List of changes from consented scheme:

Client Sign Off	Architect/Originator: Tate Harmer	Unit G182, Stamford Works, 3 Gilt Street, London N16 8JH Tel: +44 (0)207 241 7481 Email: studio@tateharmer.com	Do not scale. All dimensions to be checked on site. This drawing is copyright.
	Client: Platinum Land	8 Querpel House, 1 Duke of York Square, Kings Road, London, SW3 4LY	Date of Origin: 28.11.17
	Project: Belsize Park Firestation		Drawn By: TS
	Drawing Title: Proposed and Existing North Elevation		Scale: 1:100 @ A1
	Drawing Number: BFS THA PR PA 310 P3		Drawing Status: Planning

PROPOSED NORTH ELEVATION

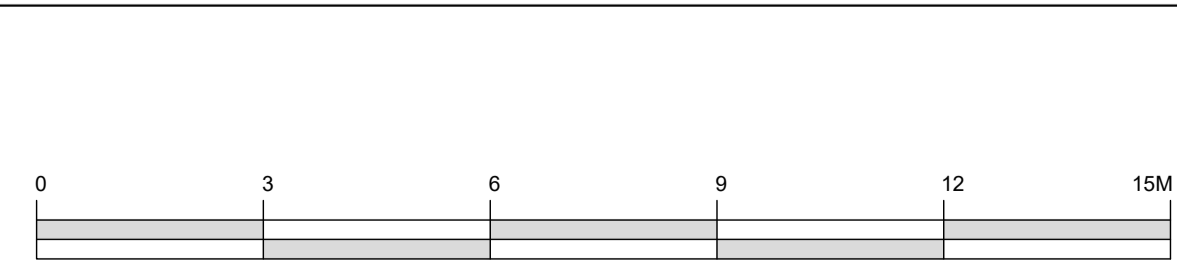
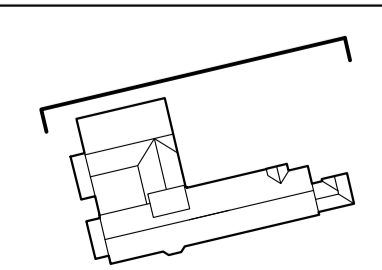
- Basement lowered by 85mm.
- Side extension lowered by 200mm.
- Dormer cheeks made to match dimensions as per existing dormer windows in courtyard.

- 3 x new DT01 dormers
- 2 x Bird Box Type 2
- New dormer type DT04
- New east extension serving Unit 1
- New single glazed leaded window
- Stone padstone
- New single glazed leaded door and window
- New New single glazed leaded window to existing building fabric
- New single glazed leaded door to existing building fabric
- New single glazed leaded window to replace existing door

- New gate and fence
- New single glazed leaded door
- Red brick, to match existing
- Stone quoins
- Window to be replaced
